AERONCA AIRCRAFT CORPORATION

SERVICE LETTER NO. 22

SUBJECT: Improved Model 15AC firewall door catch (Ambulance - Cargo - Seaplane).

SKETCH #1 FOR USE WITH SERVICE LETTER NO. 22

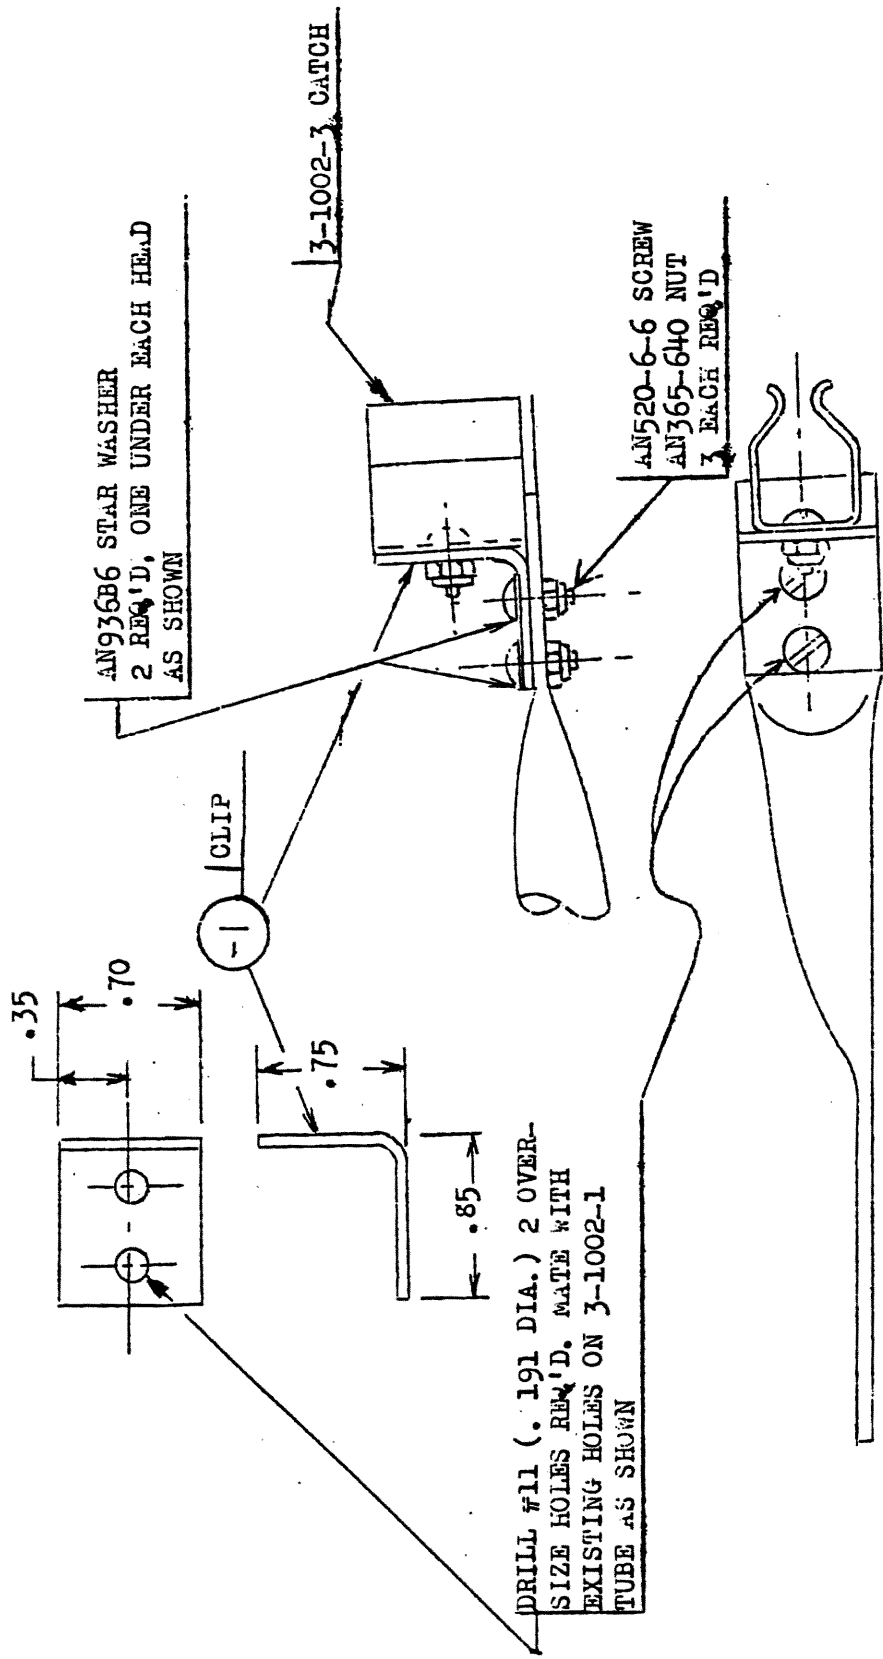
A simple modification of any existing firewall door catch will greatly improve the service life of the catch and at the same time provide more spring tension to keep the door open in higher cross winds.

1. Remove the existing female spring catch from the firewall tube.
2. Fabricate a "-1" clip (See sketch).
3. Install a 3-1002-3 female spring catch on the "-1" clip (See sketch).
4. Install the clip-catch combination on the firewall tube. NOTE: The oversize holes in the "-1" clip will permit enough play to insure direct alignment of the new 3-1002-3 female spring catch with the male catch on the door.

AN936B6 STAR WASHER  
2 REQ'D, ONE UNDER EACH HEAD  
AS SHOWN

3-1002-3 CATCH

AN520-6-6 SCREW  
AN365-640 NUT  
3 EACH REQ'D

DRILL #11 (.191 DIA.) 2 OVER-  
SIZE HOLES REQ'D. MATE WITH  
EXISTING HOLES ON 3-1002-1  
TUBE AS SHOWN

-1 CLIP MATERIAL STEEL, STOCK; .040 x 1.60 x .75

FINISH: - ZINC CHROMATED AND DOPED
